P 530315

A Repair

ON-SITE SEWAGE DISPOSAL SYSTEM HOWARD COUNTY HEALTH DEPARTMENT BUREAU OF ENVIRONMENTAL HEALTH

ADDRESS: 2665 Thompson Dr. PROPERTY OWNER: Dan Cichetti

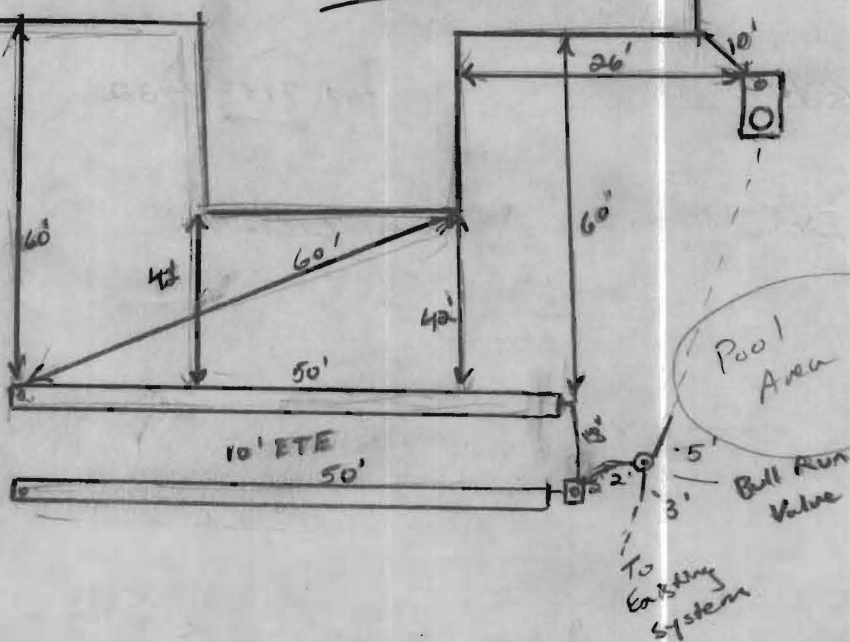
2/25/09 - In: tail (2)

47' trenches on best contour parallel to old trenches. Shot

contour, slope is 12" over 50'. Told contractor to split the difference and keep invert & bottom level. Check rear baffle & install man hole. Contractor asked to install bull run valve. That's OK (S)

2/26/09 system installed per start order. Ex. Drains fields 100% cut-in. Bull-Run valve installed but will not be used for long time. OK to backfill (CW)
